Assessment against planning controls – section 4.15, summary assessment and variations to standards

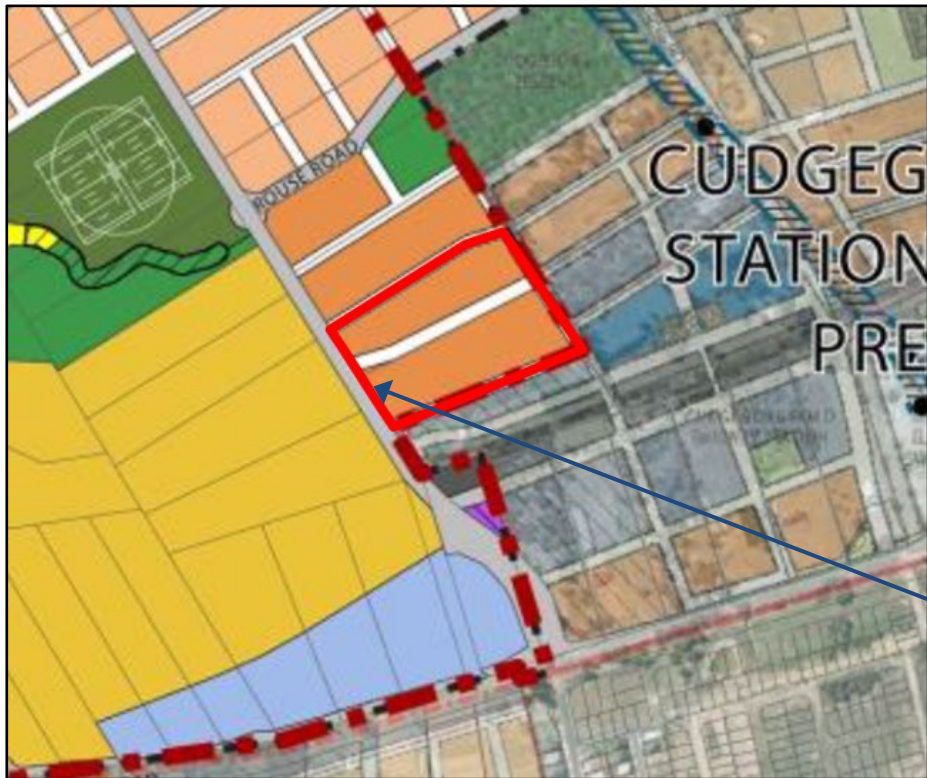
Tree removal With regard to Clause 5.9 Preservation of trees or vegetation, the proposal seeks to remove all trees from the site. The application is accompanied by an Arboricultural Development Impact Assessment Report by Birdtree Consultancy dated August 2017. It considers the removal of 122 trees on the site given their condition and the impact of the proposed development as follows: • 4 trees are dead with no visible habitat and are recommended for removal (trees 11, 37, 67 and 81). • 3 trees are in poor and declining condition and are recommended for removal (trees 63, 101 and 122). • 5 trees have decay and cavities within the trunk which places these trees at increased risk of failure. In consideration of the increased hazard posed to the future development, these trees are recommended for removal (trees 36, 66, 109, 115 and 118). • 3 trees have bark defects present at a primary junction placing these trees at increased risk of failure at this point. In consideration of the increased hazard posed to the future development, these trees are recommended for removal (trees 82, 86 and 96). • The site has been used for grazing horses. As a result a large number of the trees have significant damage to the full extent of the circumference of the trunk. These trees have been effectively ringbarked. This damage to the trunk will have a limiting effect on the ability of the trees to transport nutrients from roots to leaves and will have a significant impact on the health and condition of these trees in the short to medium term. As a consequence, these trees have low retention value. • The remaining trees are encroached upon by the proposed construction, earthworks and roadworks. These trees will not be viable to be retained and will be required to be removed.	Assessed as satisfactory

Council's position is that we should ensure that, as far as practicable, as many trees as possible within a development site are retained. However, as evidenced above, the condition of the trees and impact of the proposed development do not warrant their retention. It is also noted that the intended deletion of the ILP road along the southern boundary creates the opportunity for additional landscaping, including large trees, which will be managed by conditions. Overall, the proposal satisfies the objective of the clause to 'preserve the amenity of the area through the planting of new trees and other vegetation', by providing landscaping around the perimeter of the development and the internal courtyard areas. It is recommended a condition is imposed requiring future detailed DAs to provide at least 50% of their trees and vegetation as native species.	
--	--

Figure 3: Extract of the Riverstone East ILP (left) indicating the half road along the southern boundary of the site, and Area 20 ILP (right) without the road

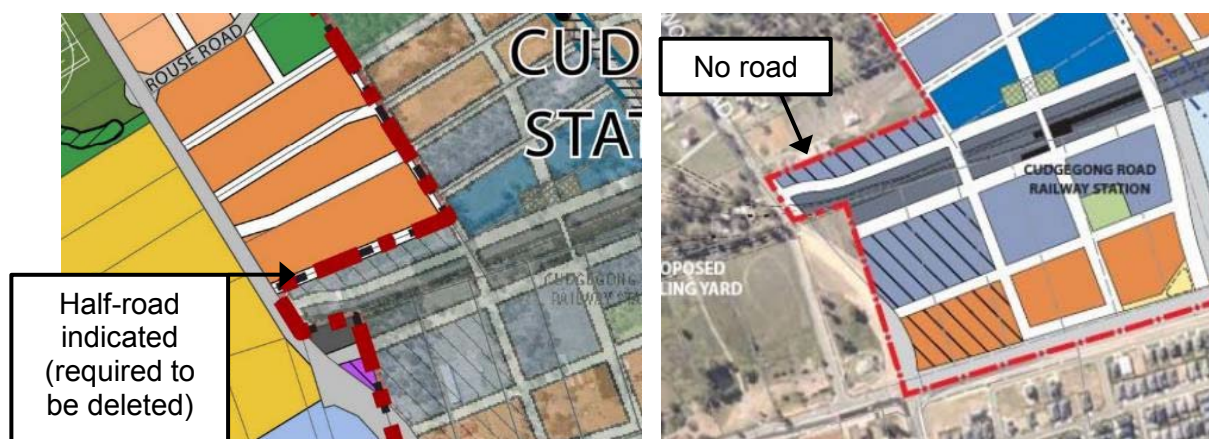
As explained in section 7.2 of the Assessment Report, the half road along the southern boundary of the site is to be deleted by separate action by Council, as shown in Figure 3 below.
